Re: Construction Close Out - BU# 871584 App# 529712– T-Mobile Site ID: CT11189E  
EM-T-Mobile-054-210305 – Exempt Modification  
115 Birch Mountain Road Glastonbury, CT

## Modification Inspection Report

**Crown POC:** Dan Vadney  
3 Corporate Park Drive, Suite 101  
Clifton Park, NY 12065  
**BU Number:** 871584  
**Site Name:** John Tom Hill  
**Site Address:** 115 Birch Mtn. Road, Glastonbury, Connecticut 06033, Hartford County, USA

**ETS REDLINE DRAWINGS  
 PASSING MI**

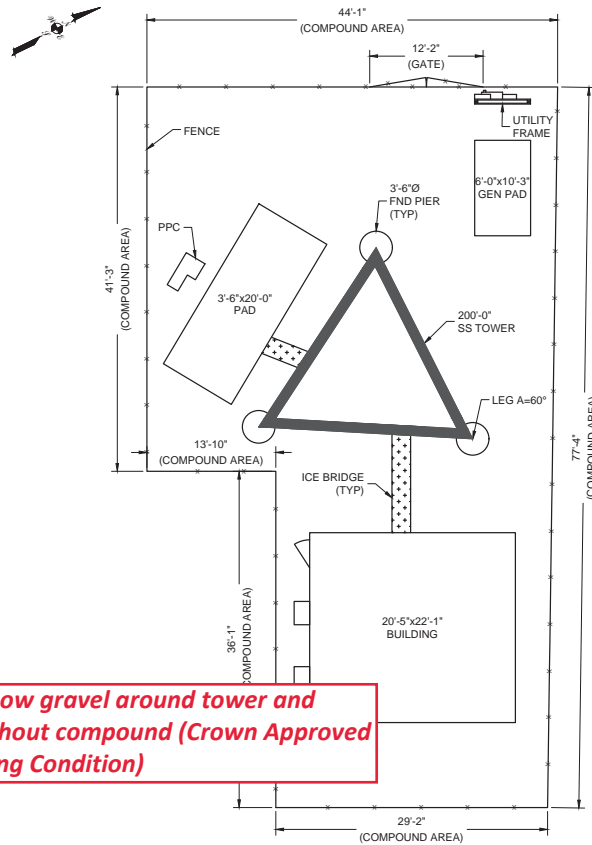
Looking for EOR direction  
 The existing anchor rods are 9.5" from the side wall of the caisson. The drawings call out 10" holes with an 9" embedment. Can we drill 9" holes and do a 8" embedment?  
 -  
 Please use a 9" hole and keep the 9" embedment. The extra 1 inch for the drill hole can be waived.  
 If there are still concerns with encountering the AR's, please reach back out, and we can revalue the calculations and acceptable embedment depth.

Please use a 9" hole and keep the 9" embedment. The extra 1 inch for the drill hole can be waived.

If there are still concerns with encountering the AR's, please reach back out, and we can revalue the calculations and acceptable embedment depth.

**TOWER MODIFICATION SCHEDULE**

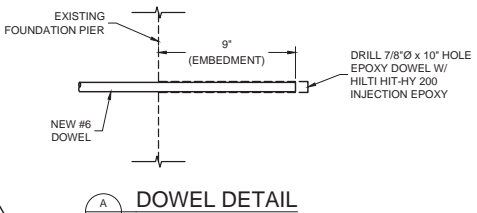
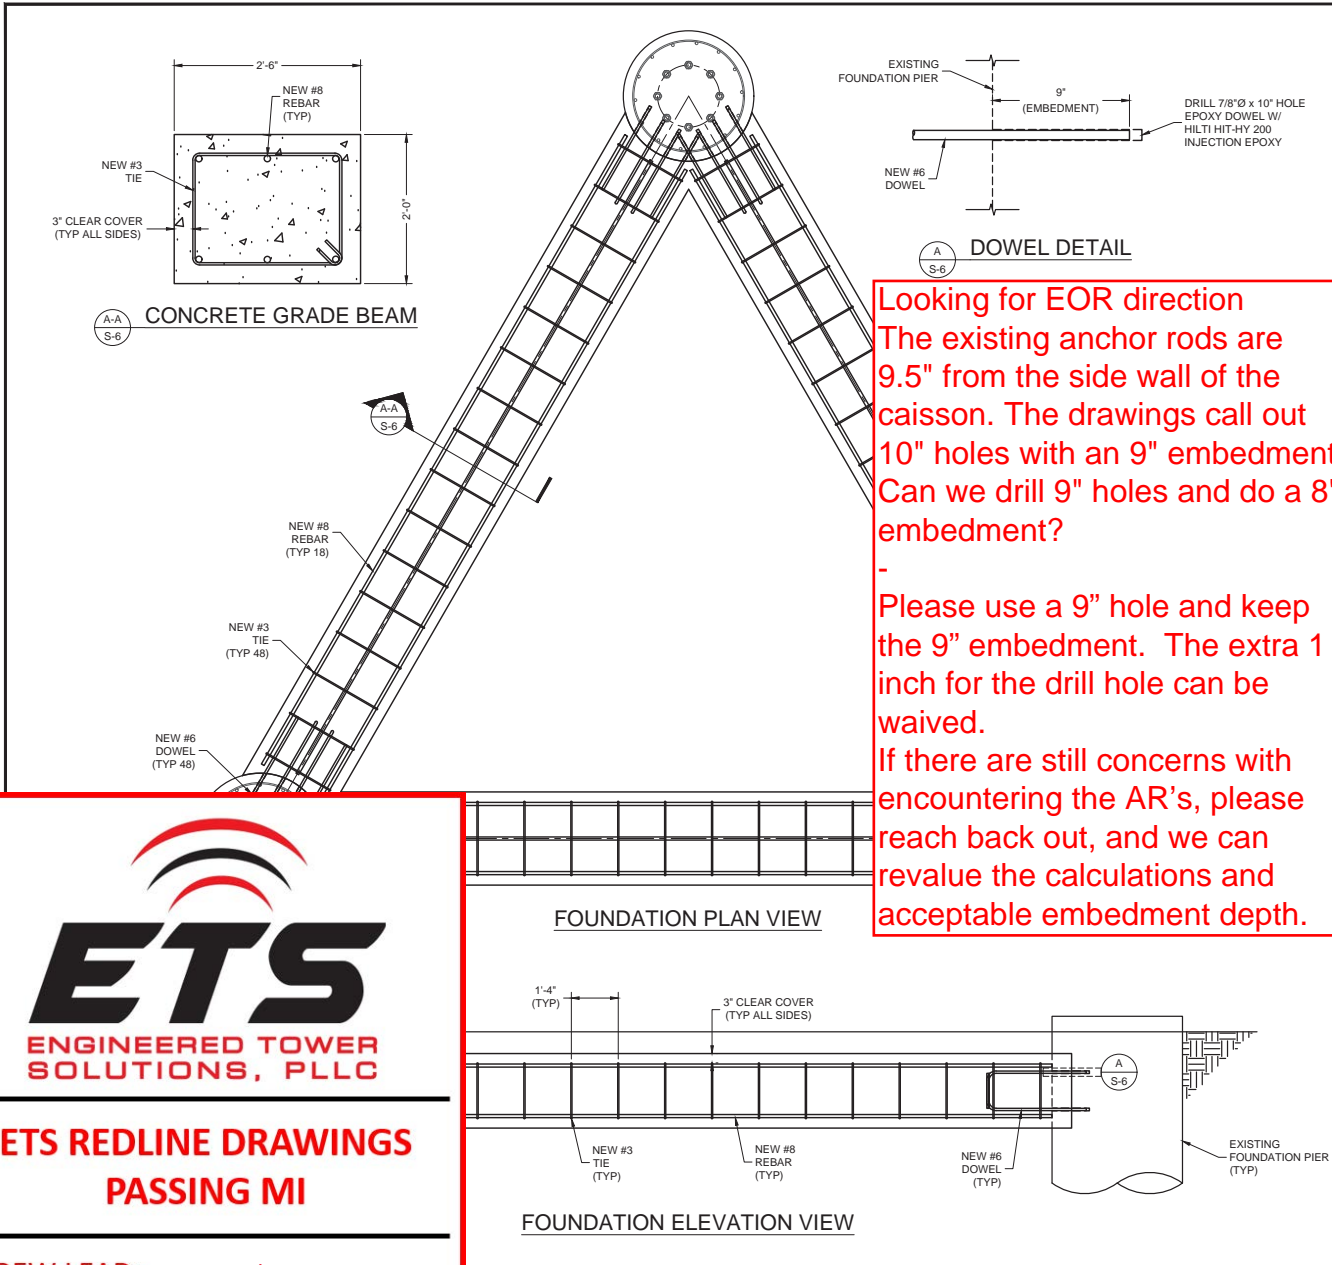
**PL#1: Low gravel around tower and throughout compound (Crown Approved - Existing Condition)**
